MILITARY SPECIFICATION

MODULES, STANDARD ELECTRONIC

MEMORY, RANDOM ACCESS, DIGITAL, KEY CODE SYT

This amendment forms a part of Military Specification MIL-M-28787/193A(EC), dated 3 August 1979, and is approved for use by the Naval Electronic Systems Command, Department of the Navy, and is available for use by all Departments and Agencies of the Department of Defense.

FIGURE 8. V_{out} (low-loaded) test circuit for table IV.

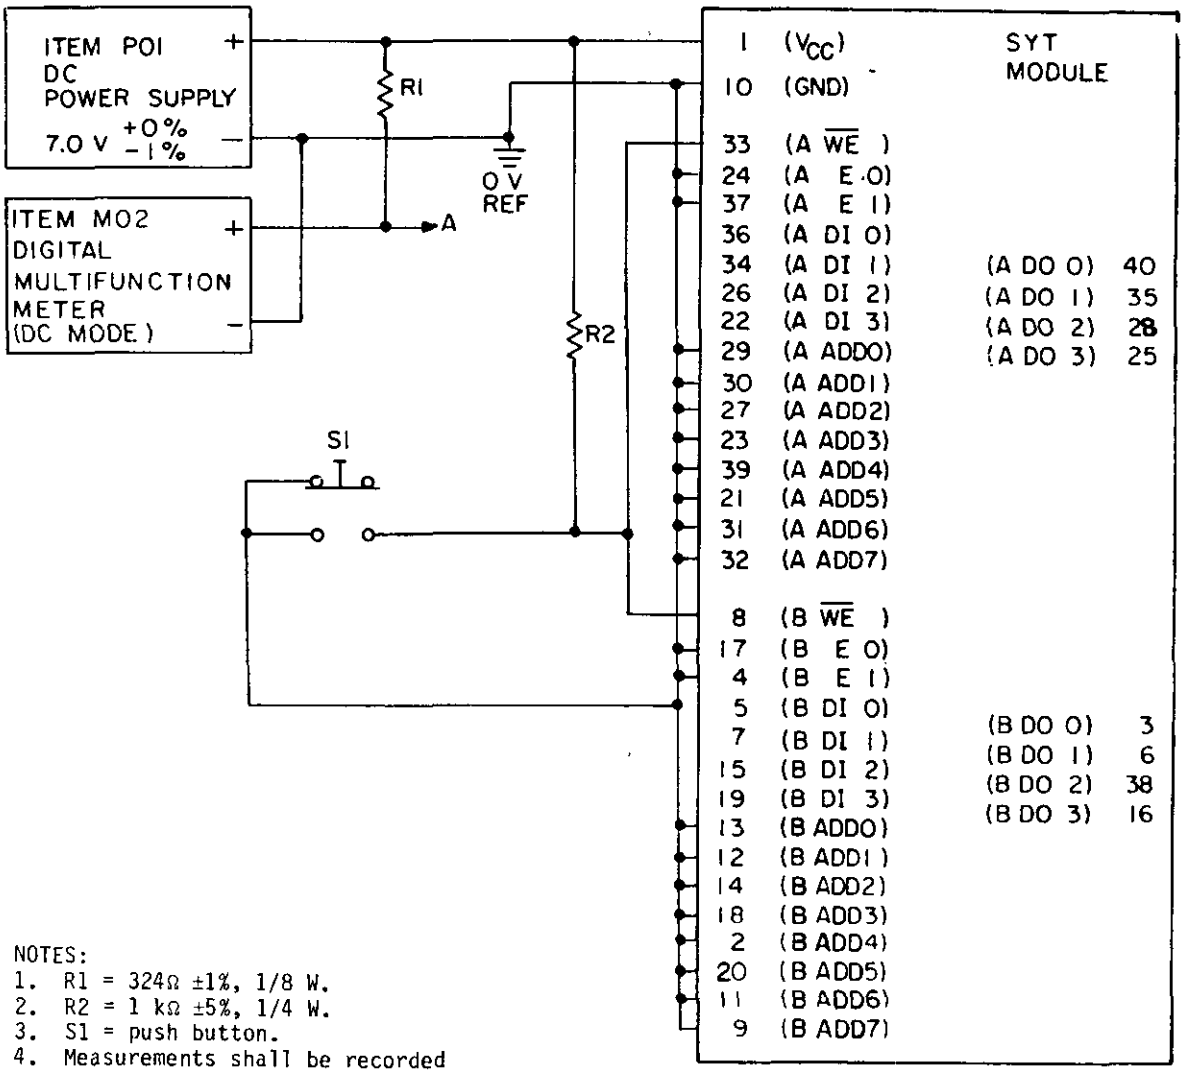
FIGURE 8: Delete and substitute new figure 8 as printed on page 4 of this amendment.

FIGURE 12. Input clamp diode voltage test circuit for table VIII.

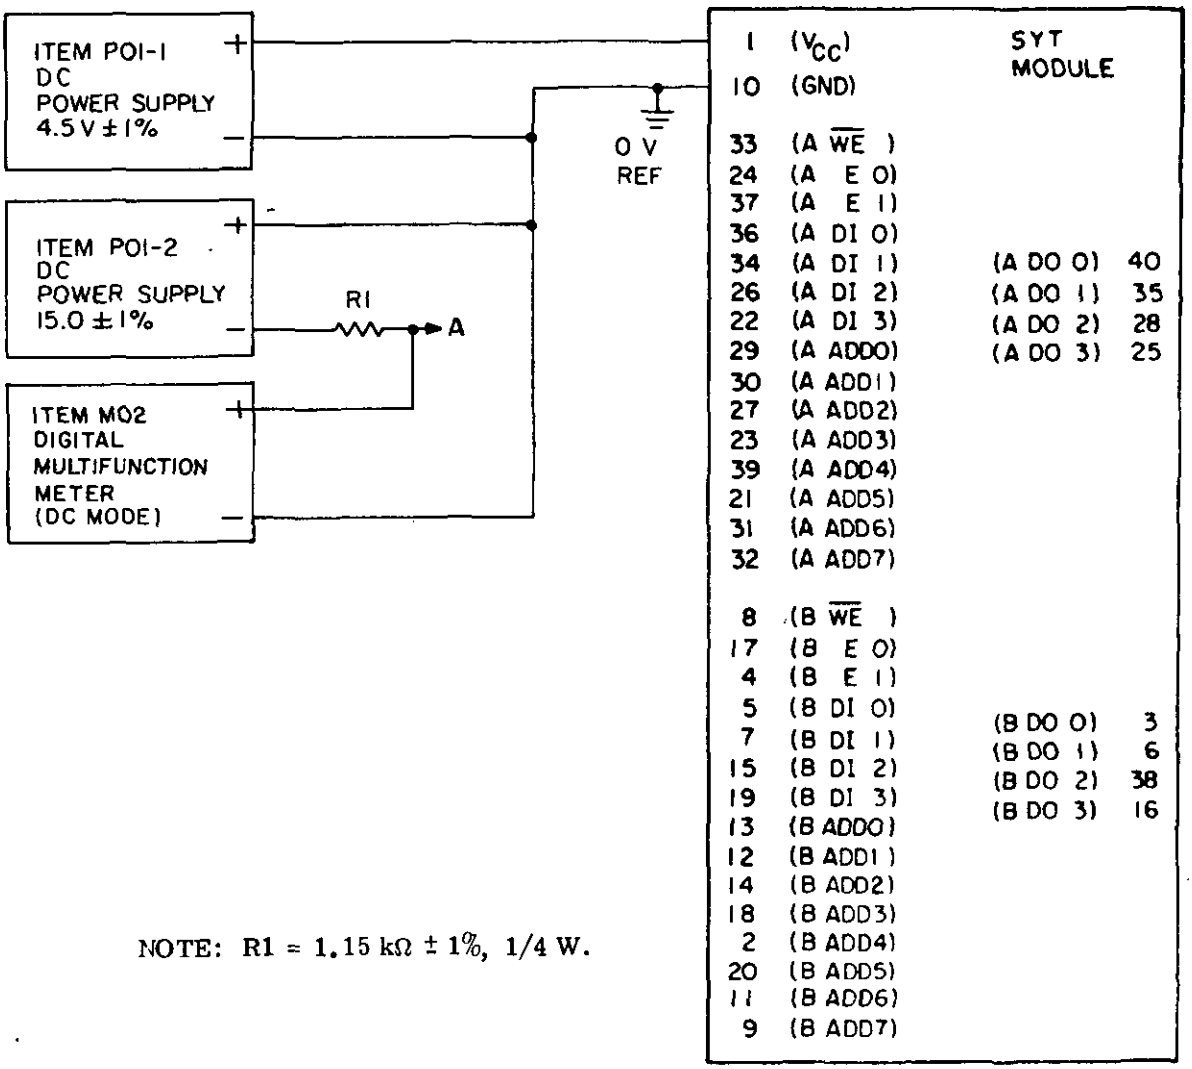
FIGURE 12: Delete and substitute new figure 12 as printed on page 5 of this amendment.

FIGURE 13. Static output voltage (low-level and high-level) test circuit for table IX.

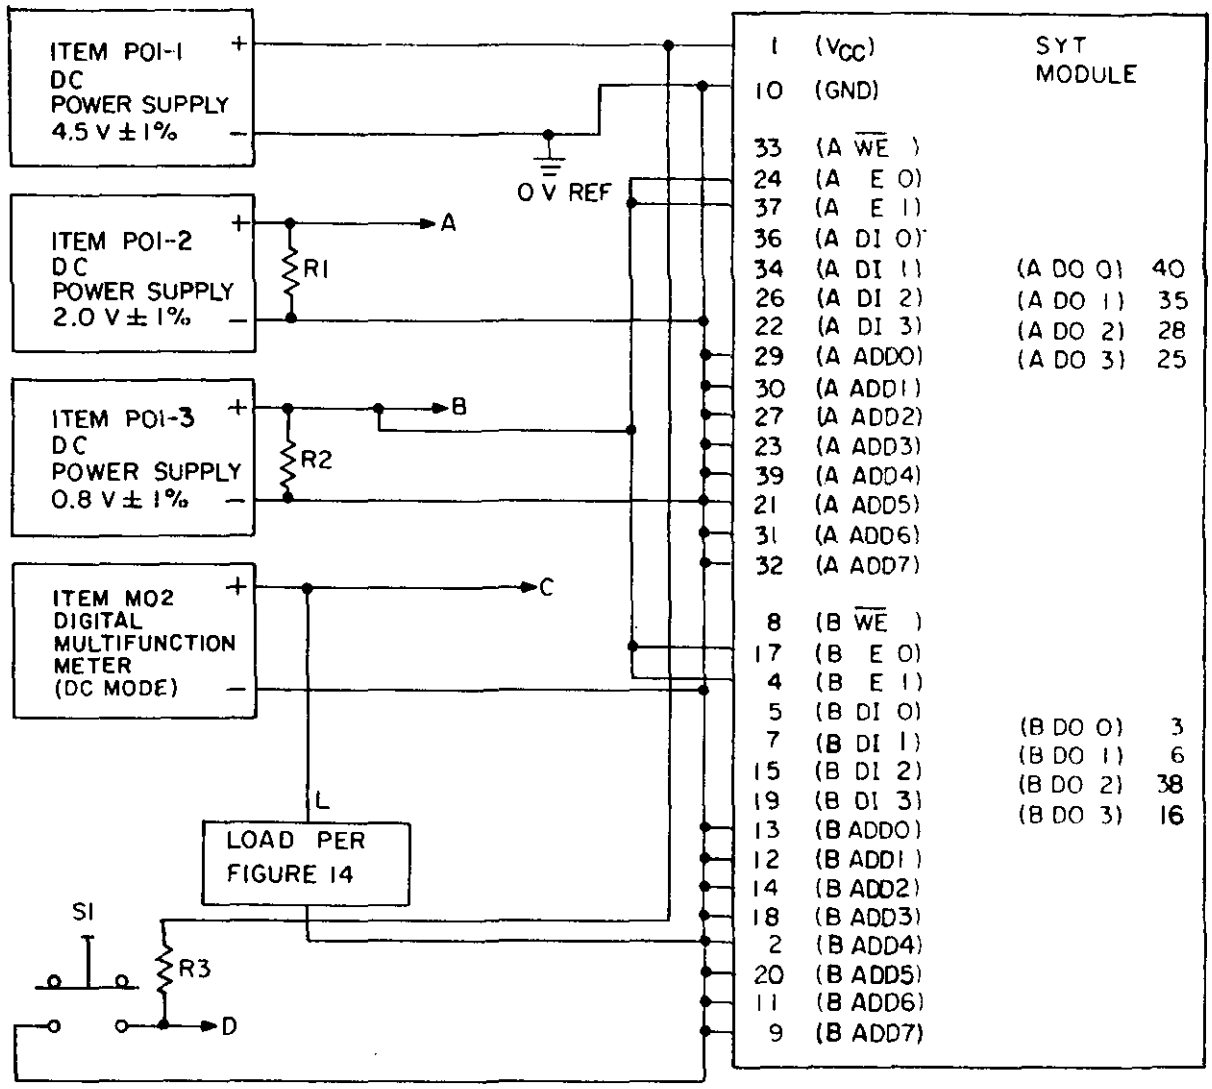
FIGURE 13: Delete and substitute new figure 13 as printed on page 6 of this amendment.

FIGURE 18. Address threshold (low-level and high-level) test circuit for tables XIII and XIV.

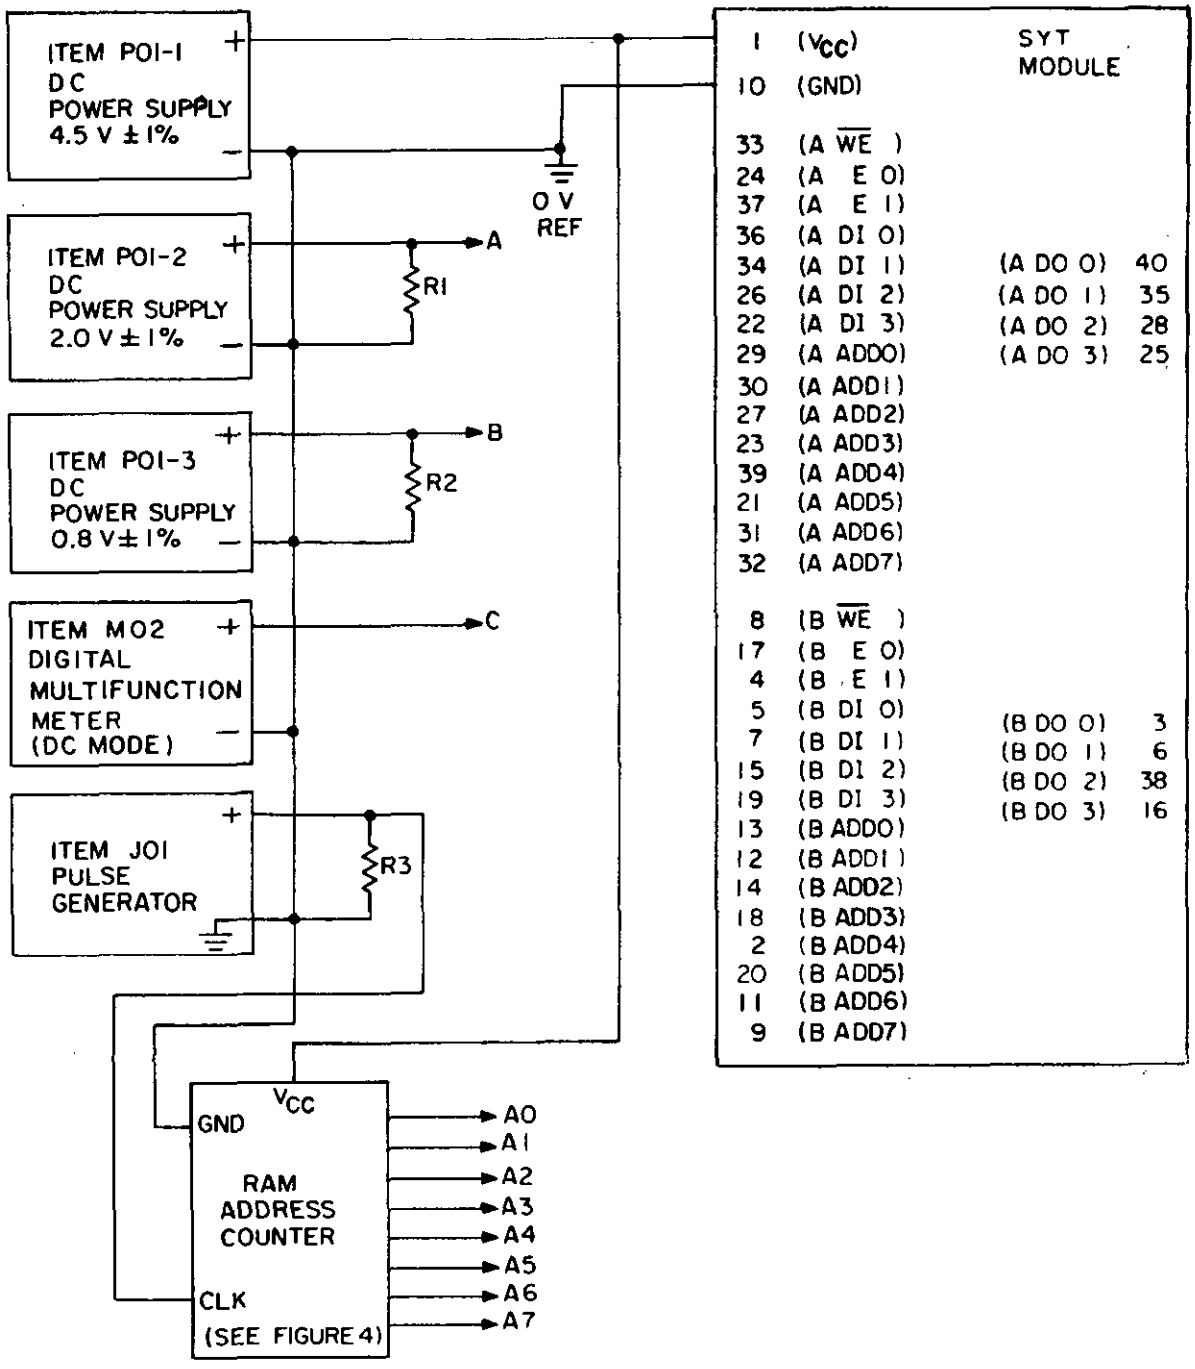
FIGURE 18: Delete and substitute new figure 18 as printed on page 7 of this amendment.

FIGURE 25. Walking-one-walking-zero test pattern circuit for table XVIII.

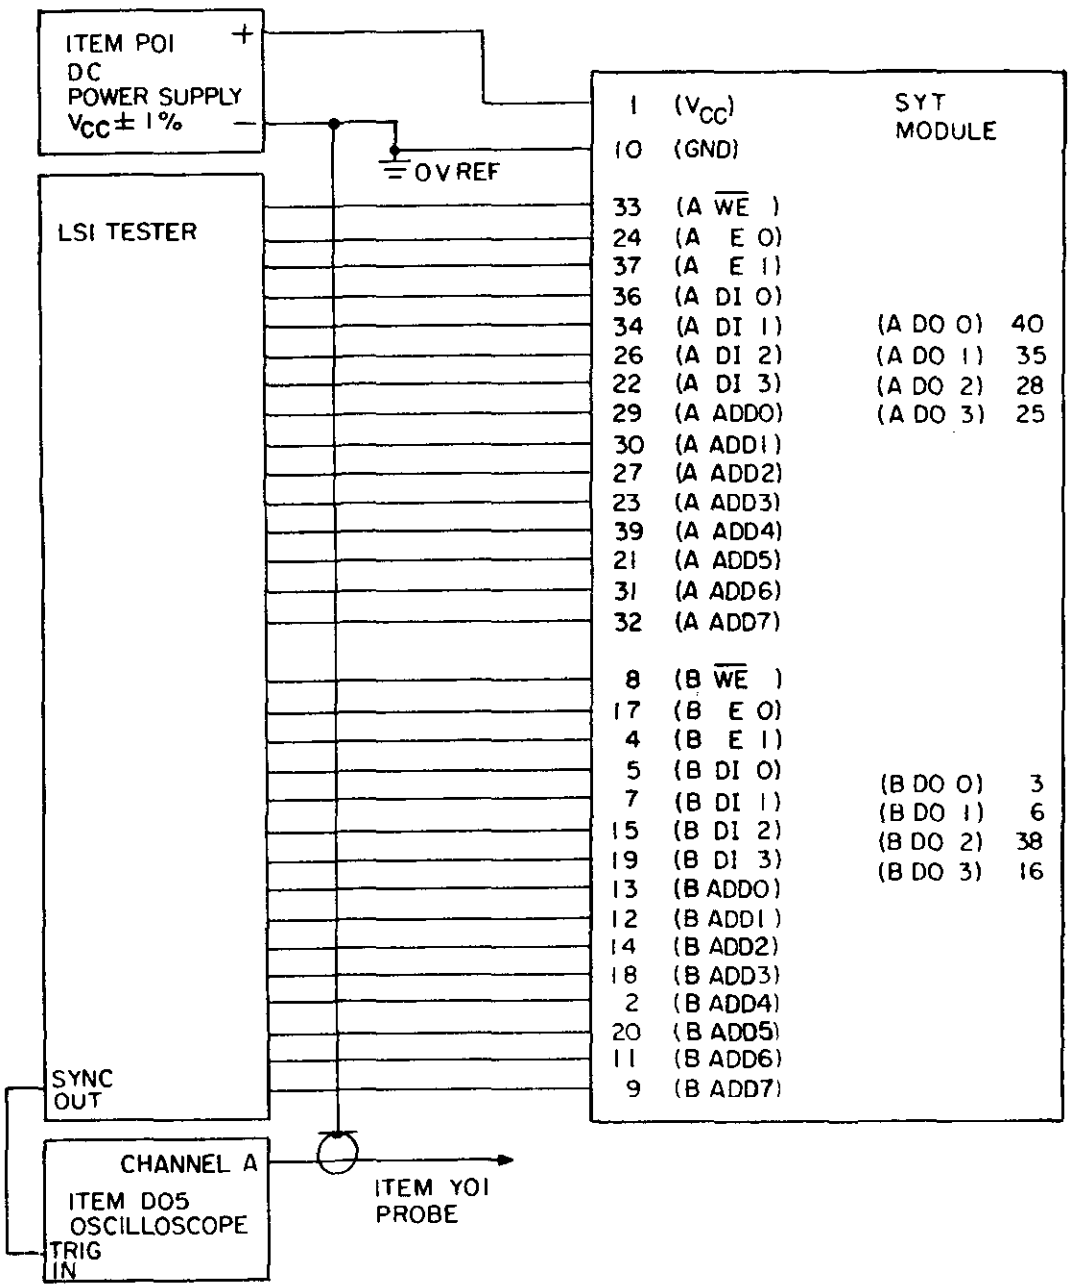
FIGURE 25: Delete and substitute new figure 25 as printed on page 9 of this amendment.

FIGURE 29. Galloping-one-galloping-zero test pattern circuit for table XIX.

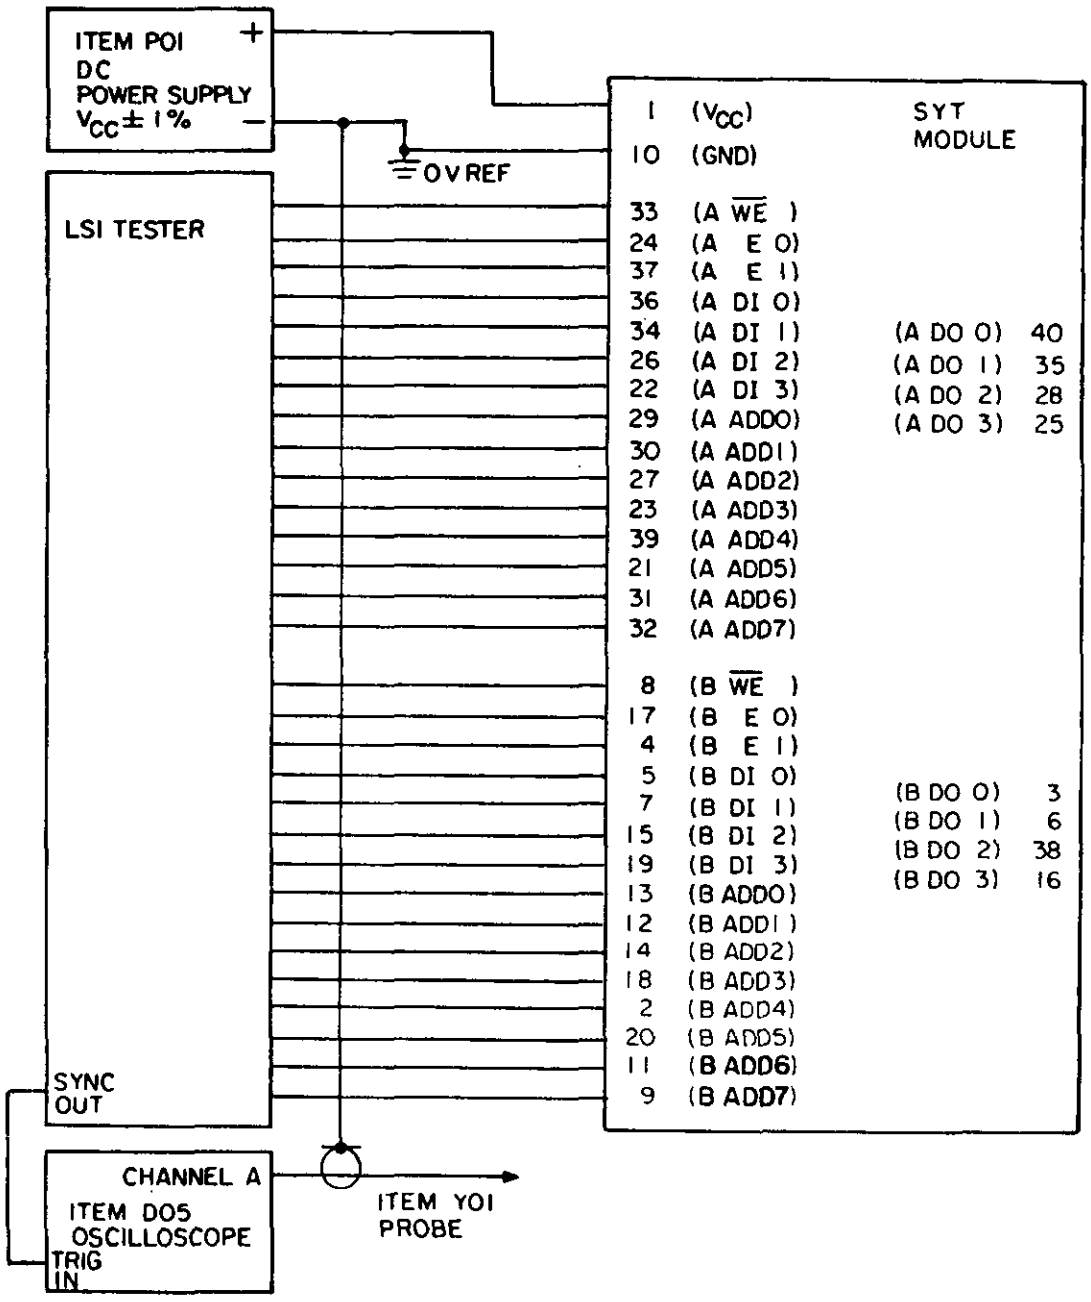
FIGURE 29: Delete and substitute new figure 29 as printed on page 10 of this amendment.

FIGURE 33. Inter-address write-recovery-one-write-recovery-zero test pattern circuit for table XX.

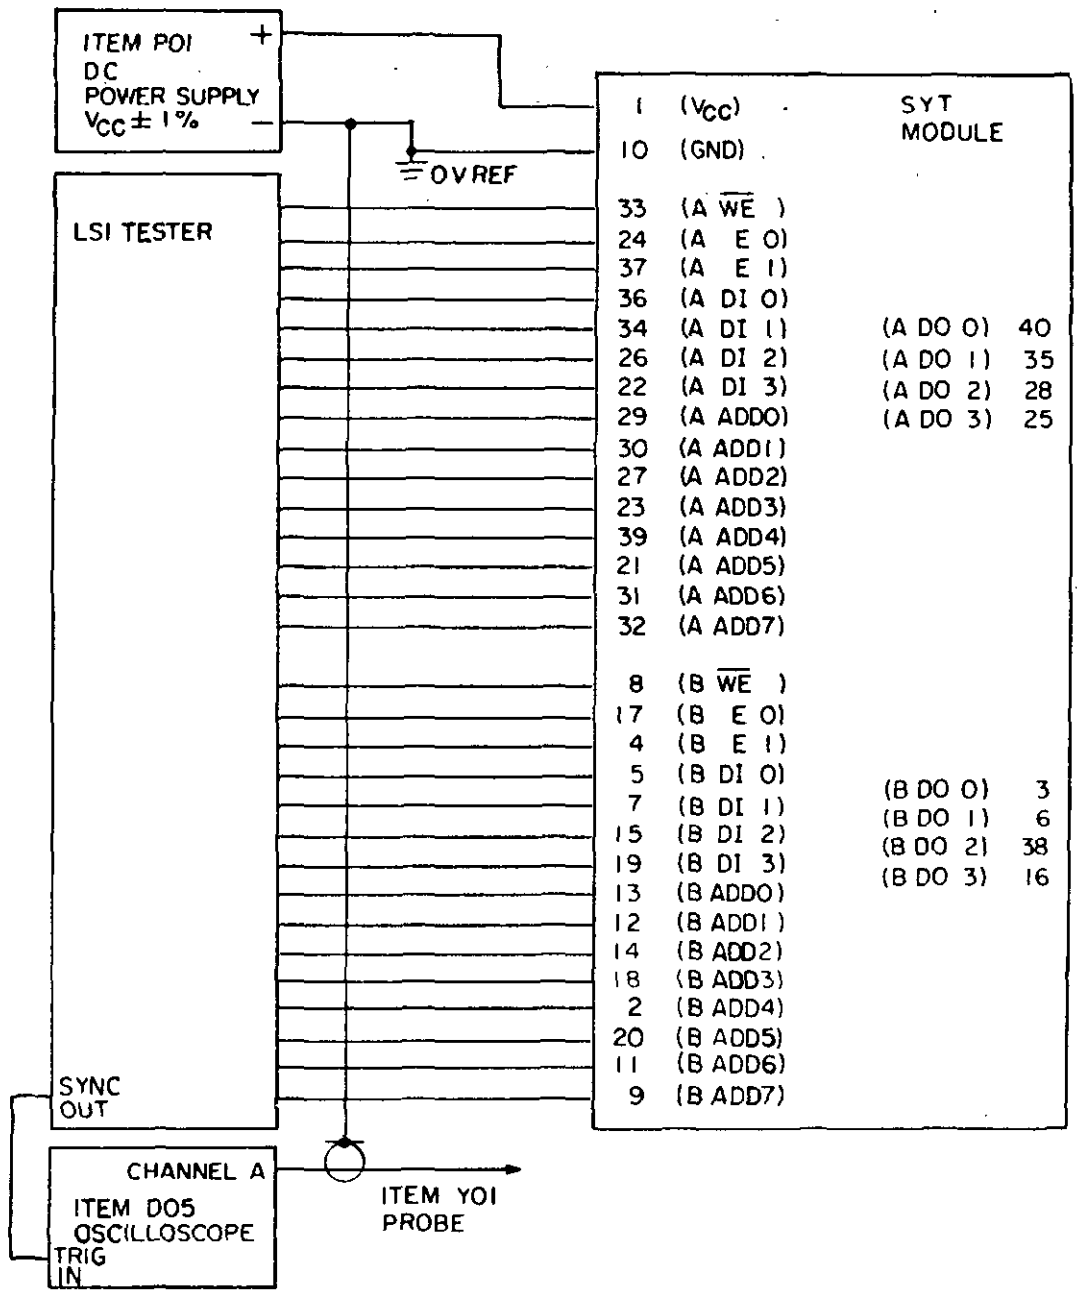
FIGURE 33: Delete and substitute new figure 33 as printed on page 11 of this amendment.

FIGURE 37. Marching intra-address write-recovery-one-write-recovery-zero and enable/disable test pattern circuit for table XXI.

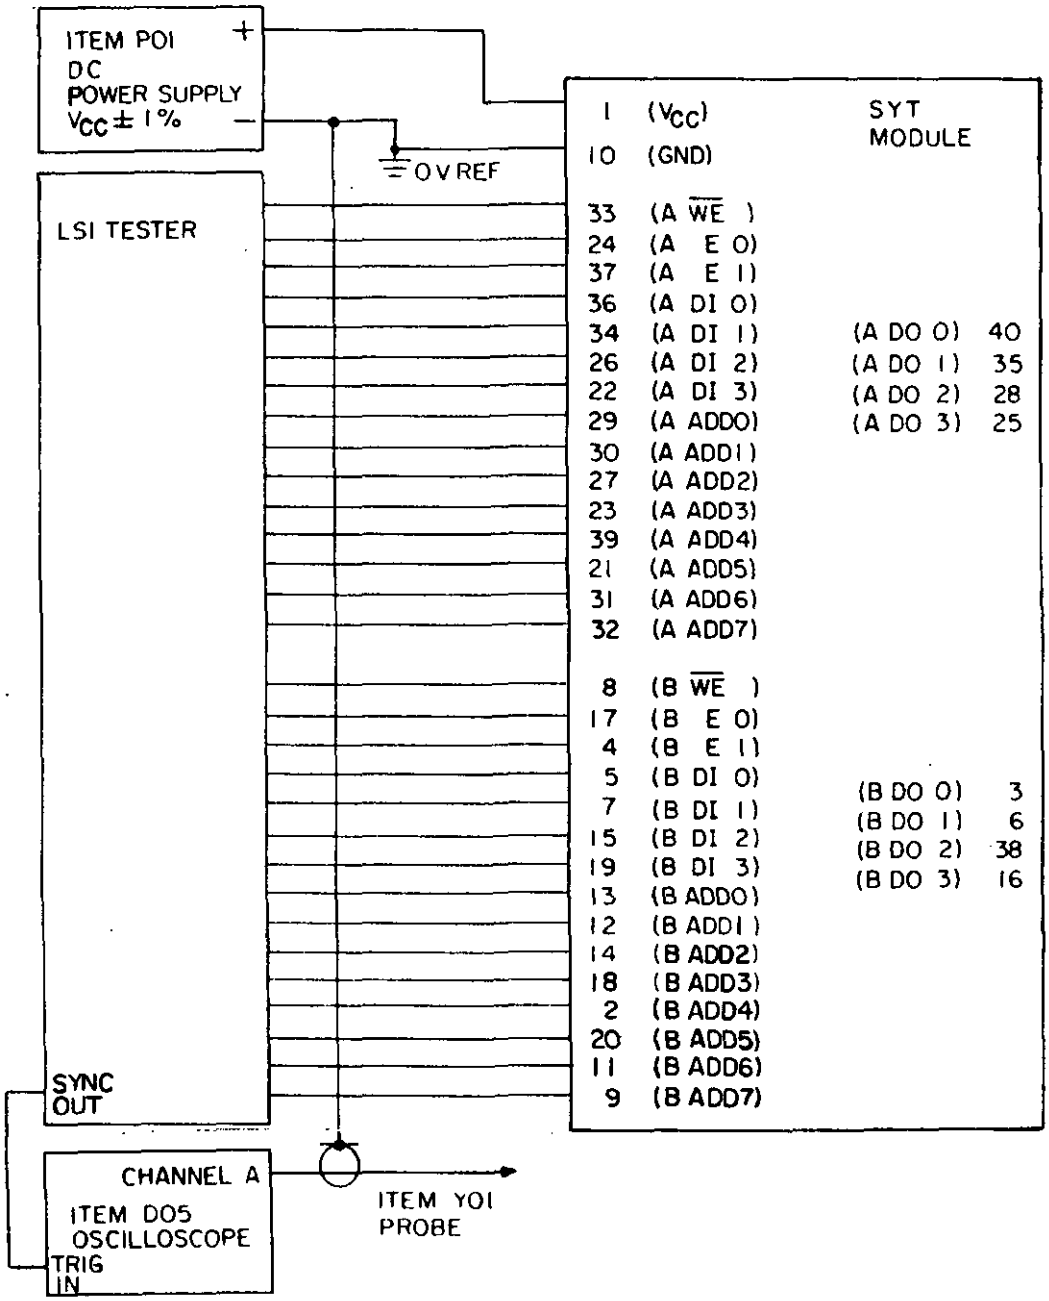
FIGURE 37: Delete and substitute new figure 37 as printed on page 12 of this amendment.
